PMSTPCOL PEmails

February 10, 2010
U7-C-STP-NRC-100036

South Texas Project
Units 3 and 4
Docket Nos. 52-012 and 52-013
Response to Request for Additional Information

Attached are the responses to the NRC staff questions included in Request for Additional Information (RAI) letter numbers 299 and 302 related to Combined License Application (COLA) Part 2, Tier 2, Sections 3.7.1, 3.7.2 and 3.8.4.

Figure 3H.6-15: SASSI2000 Model of UHS and RSW Pump House

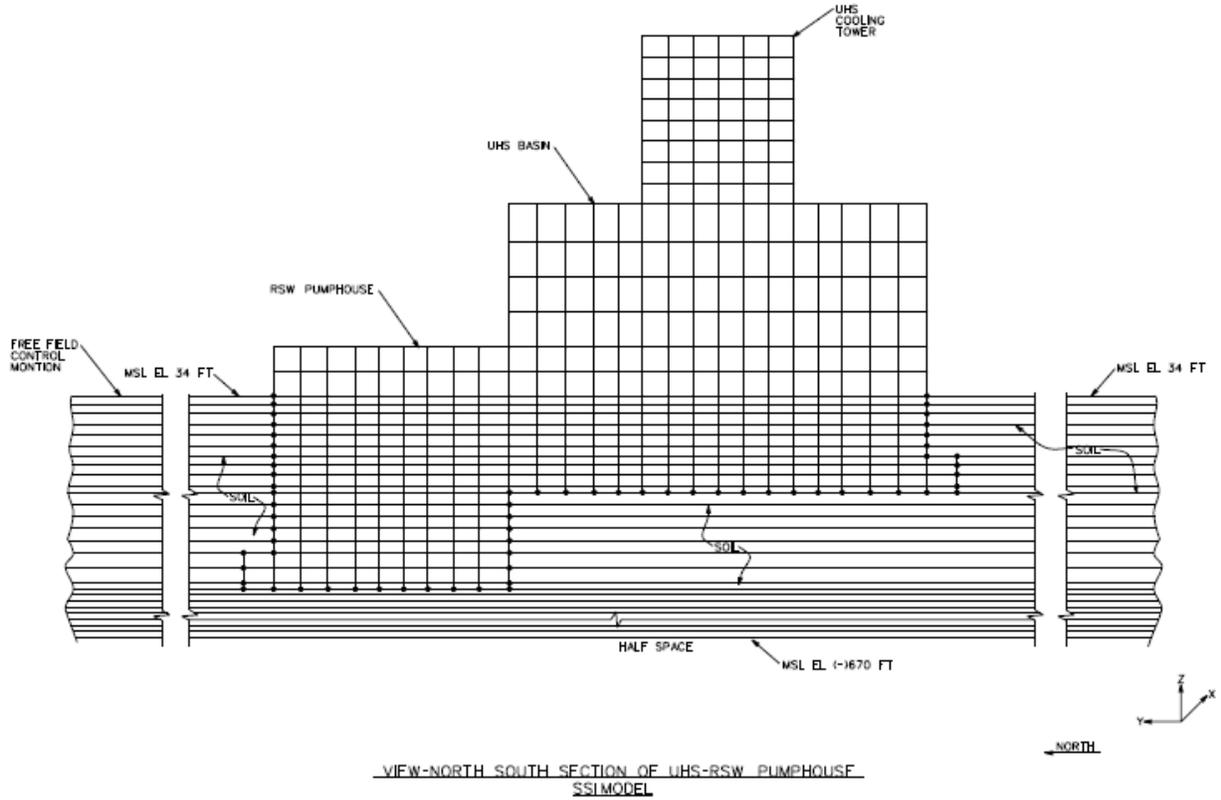
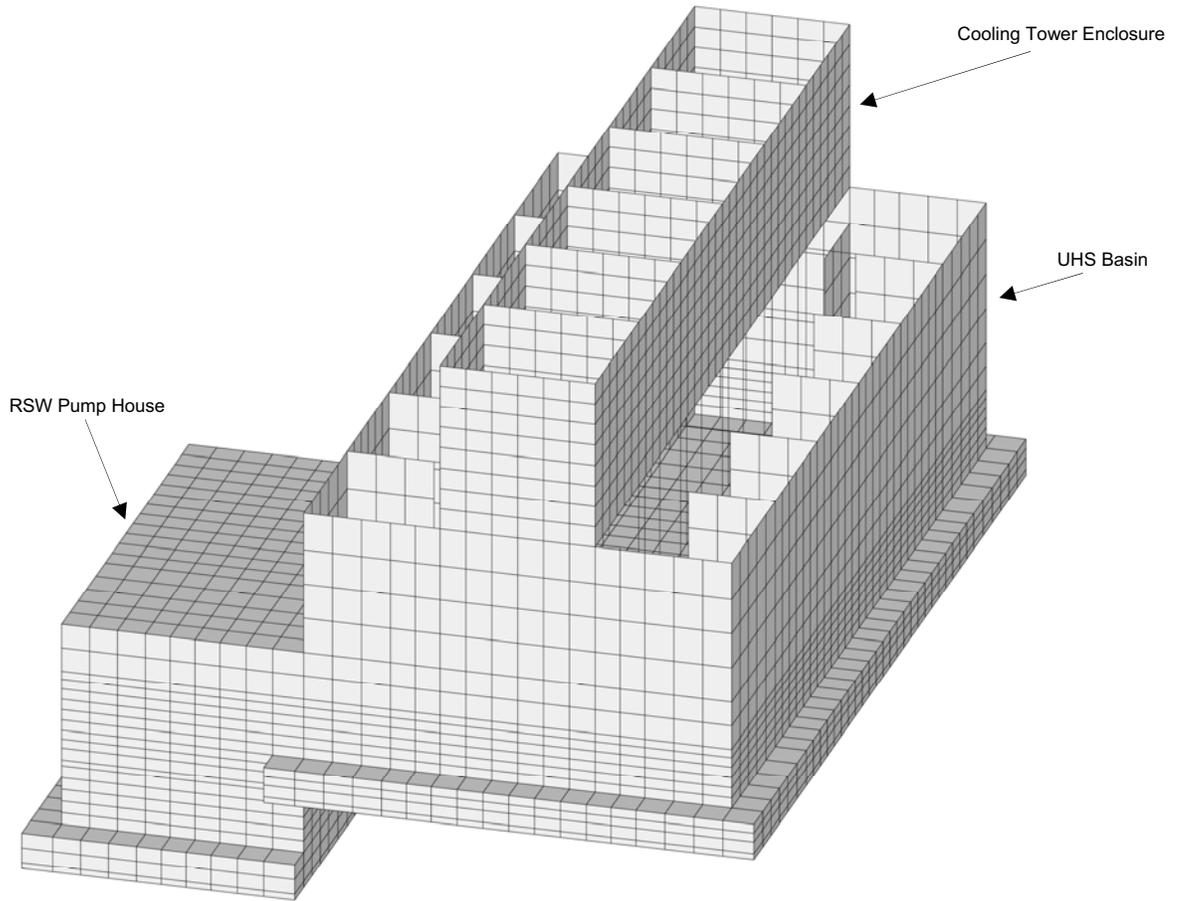
7. A figure showing the finite element model of the structure in relation to the layered soil system.
8. A description of how the ground water effects were treated in the SASSI2000 model.

7. Figure 3H.6-15 showing the north-south cross-section of the three-dimensional finite element model of both structure and soil layers was provided as part of the Supplement 1 response to RAI 03.07.01-13 (see letter U7-C-STP-NRC-090208, dated 11/19/2009) and for convenience was reproduced in part 3 above. For additional information and figures, please see the response to RAI 03.07.02-16 submitted concurrently with this response.

Figure 3H.6-138: Broadened Horizontal FRS for RSW Piping Tunnels

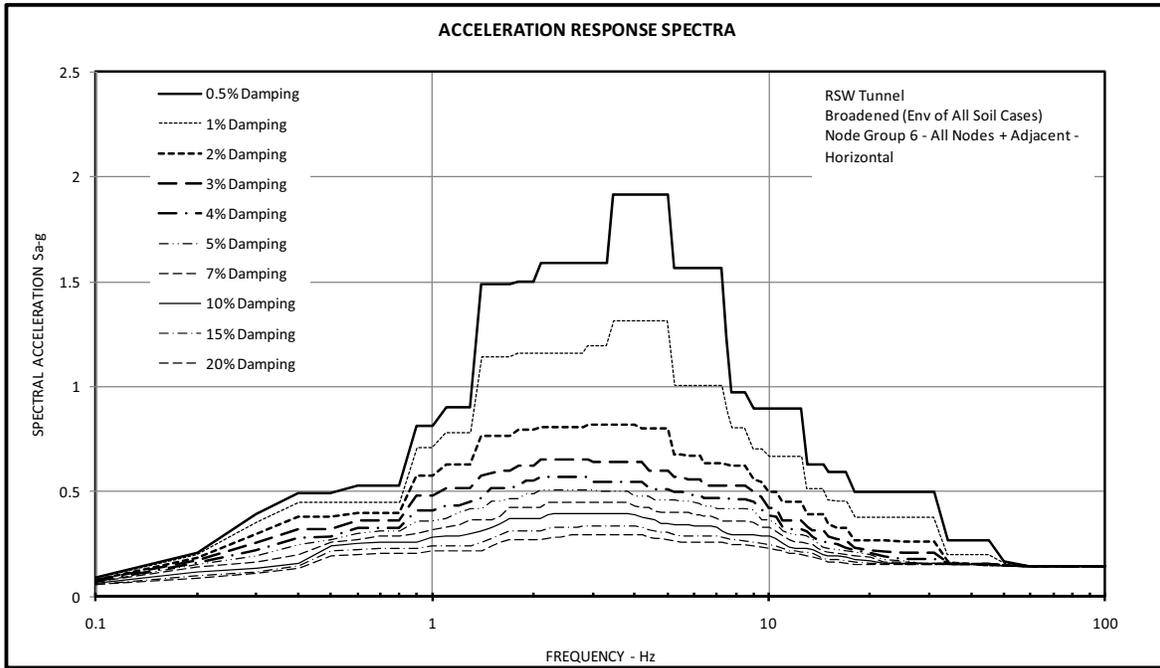
1. A description of the equivalent static analysis method used for the RSW piping tunnel.
2. A description of how the seismic and static loads were calculated and applied to the model. Show the model and boundary conditions including the soil springs used in the analysis.
3. A description of the type of strains (tensile or compression) were calculated in the RSW piping tunnel.
4. A description of how both axial strain and transverse shear demands were considered in the analysis of the RSW piping tunnel.
5. A description of how the concrete elements of the RSW piping tunnel were determined to be rigid so that there are no in-structure amplifications.
6. Describe the SSI analysis from which the accelerations are obtained to establish the SSI forces for the analysis of the RSW piping tunnel (see the last bullet in Section 3H.6.6.2.2).

In order to quantify the in-structure amplification and ensure that the use of 0.21g ZPA adequately accounted for in-structure amplification, a two-dimensional SSI analysis of the RSW tunnel is performed. Attached Figures 3H.6-138 and 3H.6-139 show the resulting amplified response spectra for all the walls and slabs of the tunnels. As can be seen from these figures, the amplified ZPA of these response spectra are less than 0.21g ZPA acceleration used for the design of tunnels' walls and slabs.

Figure 3H.6-40: SAP Finite Element Model for UHS and RSW Pump House Design

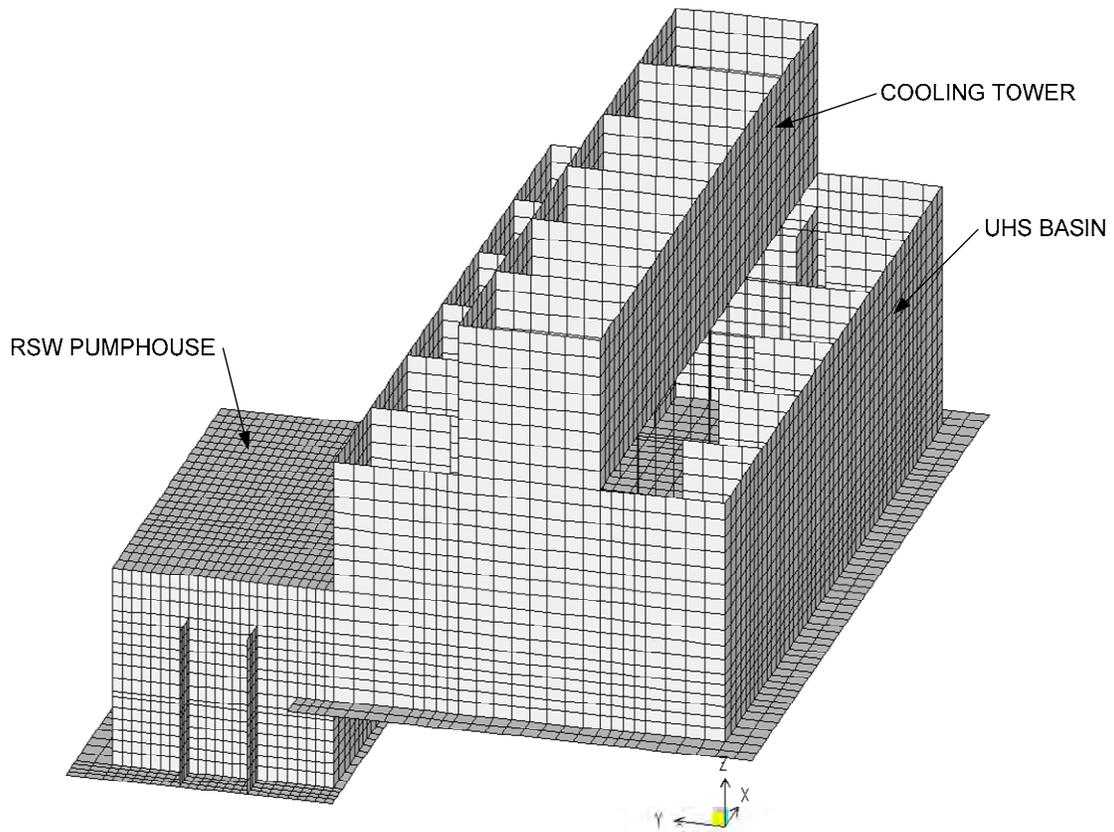
1. In the response to Item 2 of RAI 03.07.01-4, the finite element model of the UHS basin and RSW Pump House was not provided in Figure 3H.6-40 (this figure was supposed to be part of the response to RAI 03.07.01-13). The applicant is requested to ensure this information be part of Figure 3H.6-40, including a plot showing the basement slab and soil-retaining wall mesh configuration and grid sizes. The response to Item 2 of RAI 03.07.01-4 also states that, *“The model mesh size is detailed enough to model the principal features of the structure and transmit a frequency of at least 33 Hz.”* The applicant is requested to a) provide the criteria and quantitative basis to show that the element sizes are sufficiently small to transmit frequencies of up to 33 Hz for the three soil cases; and b) provide a justification that the aspect ratio of the elements is sufficiently small as not to affect the solution accuracy.

1. Figure 3H.6-40 has been provided as part of the Supplement 1 response to RAI 03.07.01-13 (see letter U7-C-STP-NRC-090208 dated 11/19/2009) and for convenience is reproduced below. Note that this figure provides the Finite Element Model (FEM) used for design of the ultimate head sink (UHS) and reactor service water (RSW) pump house. In this FEM, the basemat is represented by shell elements, whereas in the FEM model for the soil-structure interaction (SSI) analysis (see Figure 3H.6-15a) the basemat is represented by solid elements. Solid elements are required for proper modeling of interaction between the soil and the structure in the SSI analysis.

Figure 3H.6-137: Formulations Used for Calculation of Factors of Safety Against Sliding and Overturning

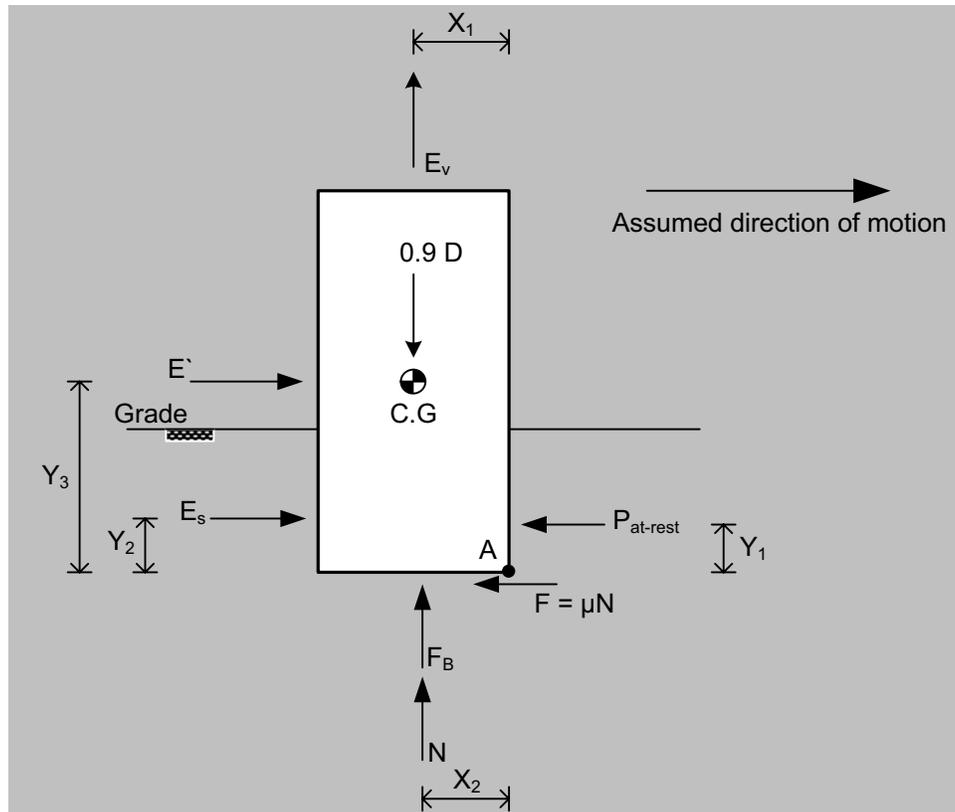
4. In the seventh and last bullet of the response to RAI 03.07.02-10, Figure 1 attached to this response shows the driving force "Es" as static and dynamic soil pressure but does not clarify the nature of the static soil pressure. The applicant is requested to clarify the nature of the driving static soil pressure in Figure 1. Also, please clarify how total at-rest soil pressure is calculated including algebraic expression. This figure with the above clarification should be included in the FSAR.

As requested, Figure 1 of the response to RAI 03.07.02-10 will be included in COLA Part 2, Tier 2 as new Figure 3H.6-137; see attached COLA mark-up.
